**CORRIGENDUM WITH REFERENCE TO TENDER DGM (MS-KTK) /
TENDER / GANTRY / 2008-09 / 3 Dated 12 / 05/ 2008**

Vertical Support

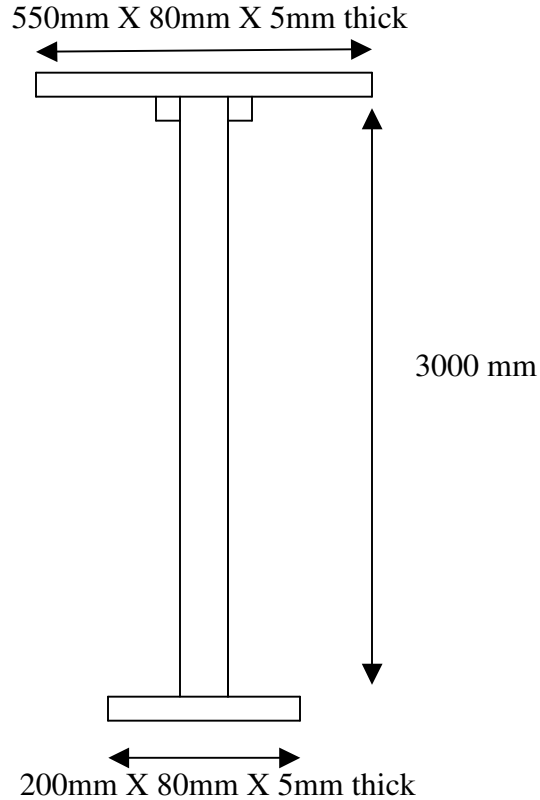
With respect to the above tender the corrigendum issued in vertical support diagram under revised page 33, the width of the pipe support both top and bottom should be taken as 80 mm. The same is applicable in revised price schedule under section XI of SI No 2. The rate should be quoted as per the changes mentioned.
